Reference: Pilot Test Work Plan Addendum

Former Chevron Service Station No. 97127
Alameda County Case No. RO0000185
10 Grant Line Road, Mountain House, California

On behalf of Chevron Environmental Management Company (CEMC), Stantec Consulting Services Inc. (Stantec) presents this *Pilot Test Work Plan Addendum* (Addendum) for the Former Chevron Service Station No. 97127, located at 10 Grant Line Road in Mountain House, California (the 'site'). This Addendum is provided in response to correspondence from Alameda County Environmental Health (ACEH), dated December 11, 2015. This Addendum describes the well installation protocols and locations of three observation wells to be constructed in addition to the approved scope of work outlined in the *Pilot Test Work Plan*, dated October 29, 2015.

FIGURE 2 – Site Plan with Proposed Wells

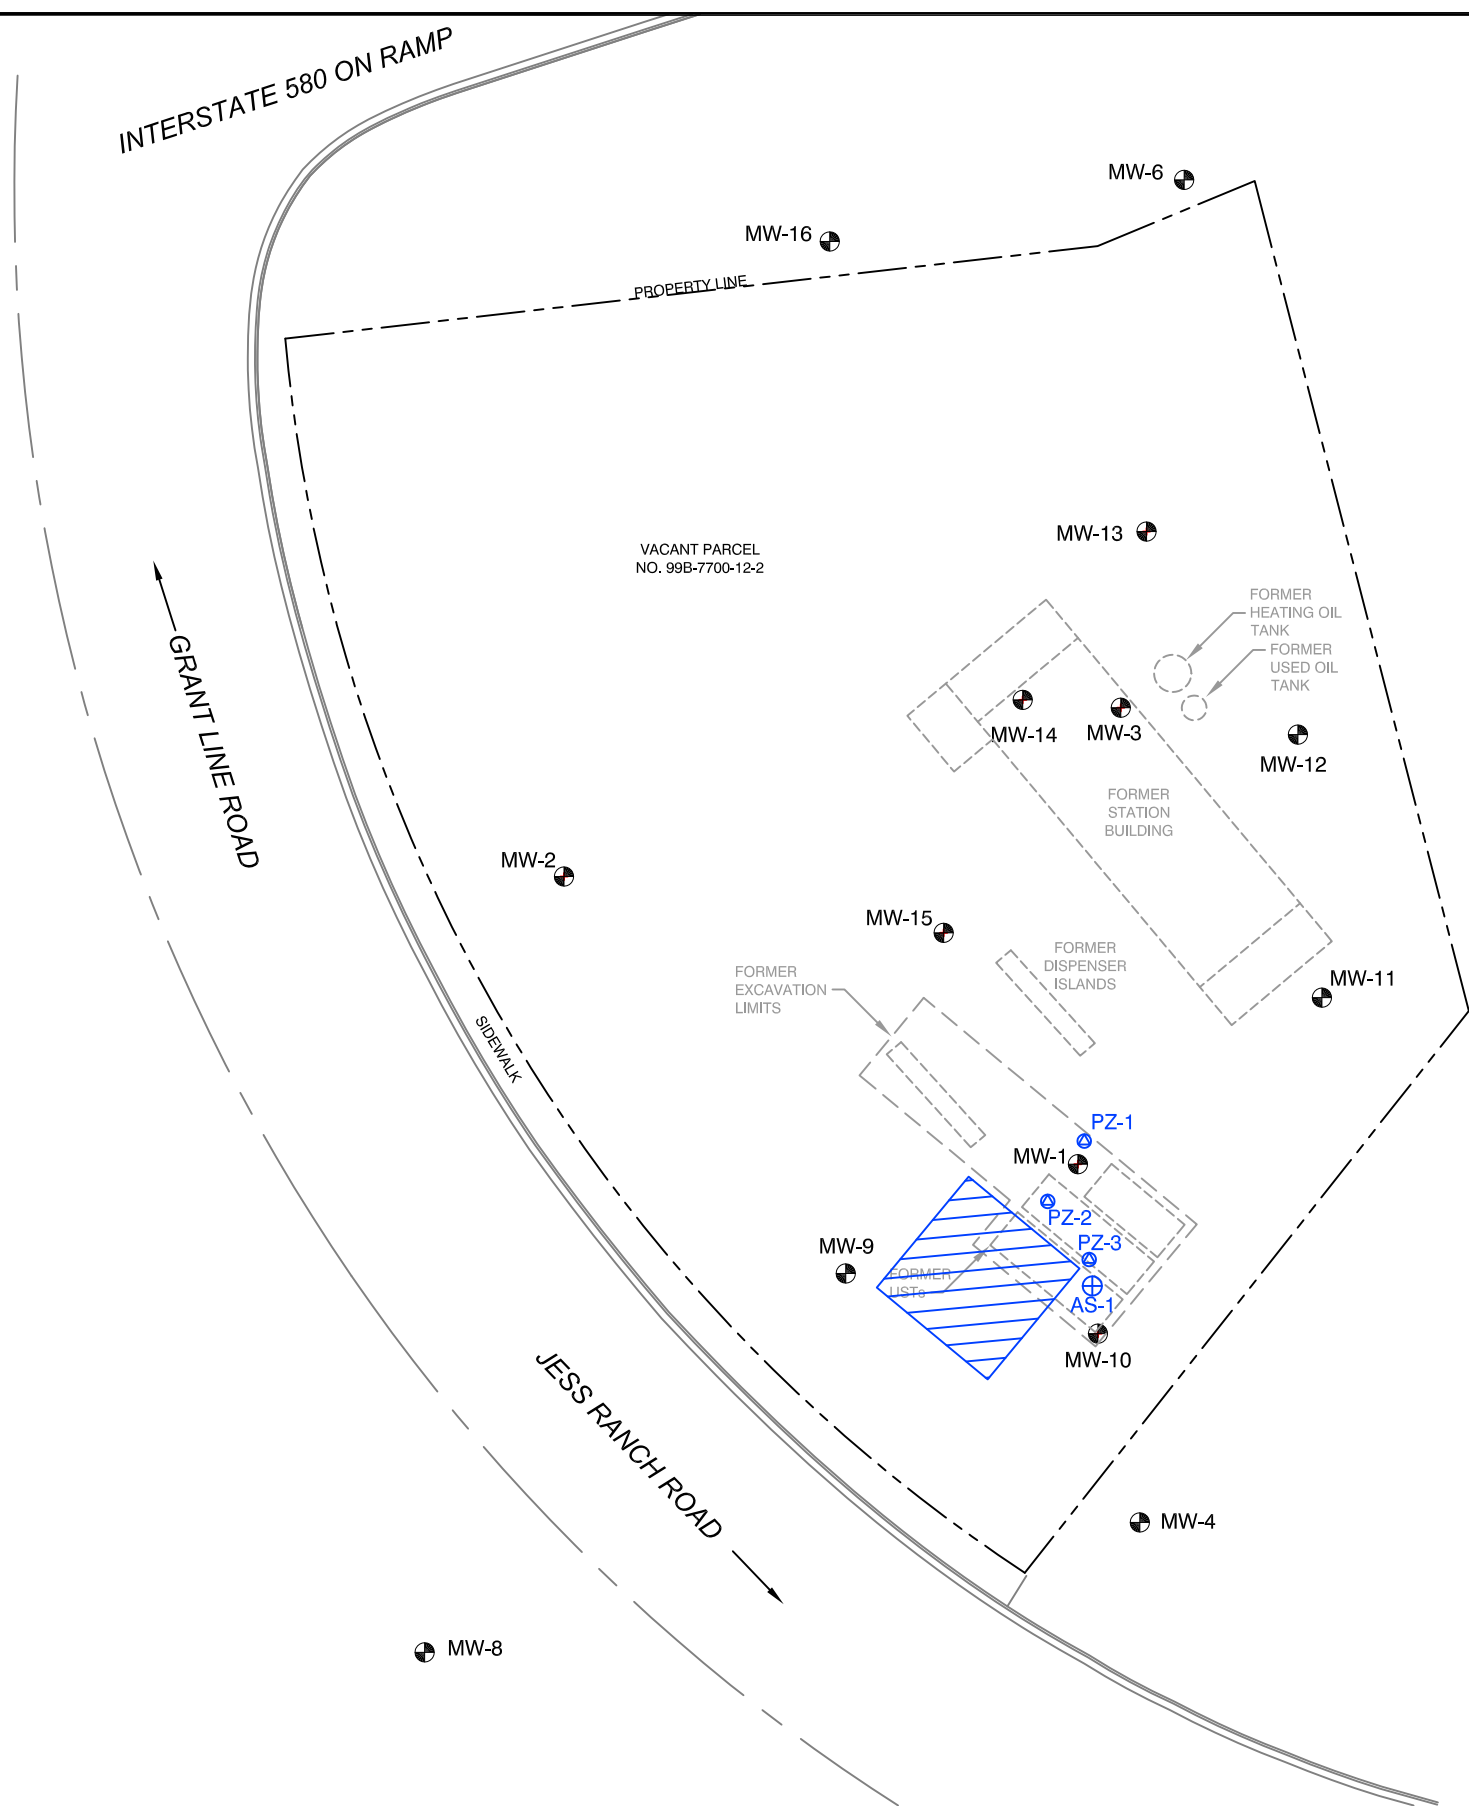
Stantec will subcontract with a C57 drilling contractor to install three piezometer wells (PZ-1 through PZ-3) to approximately 37 feet below ground surface (bgs). Proposed well depths and screen intervals are consistent with MW-1. The proposed well locations are shown in the attached revised **Figure 2**; however, actual well locations will depend on well clearance activities and field conditions. Wells will be installed using sonic drilling methods. All down-hole drilling equipment will be decontaminated before use and between drilling locations.
